Shirt & Jacket Zone Ltd.

Gobindopur,Uzampur,Moinartake,Uttarkhan,Uttara,Dhaka-1230
(23.883003N, 90.451259E)
19 September 2023

Observation

Design report needs to be updated

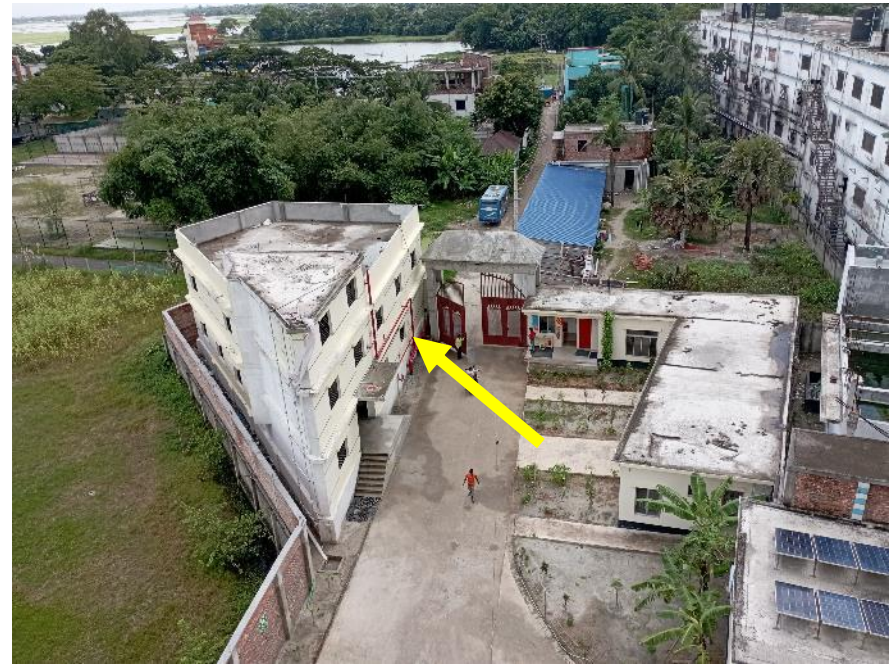
All serviceability check not provided in report

The structure is horizontally irregular

The structure is horizontally irregular and no torsional irregularity/drift check provided in report. Building engineer is required to update the design report as per 1.9.1.1 (BNBC) including all serviceability checks.

As-built floor beam layout

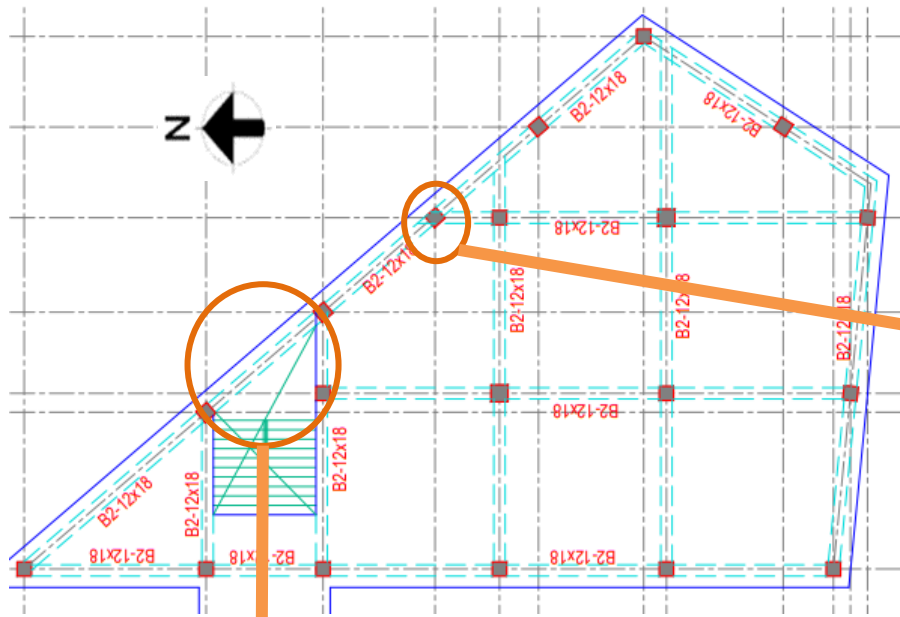
Beam layout does not match with drawing

No diagonal but straight beam at stair

As built beam layout does not match with on site condition at floor level & stair portion. Building engineer is required to update the as built structural drawing as well as FEM model and design report as per 1.9.1.1 (BNBC).
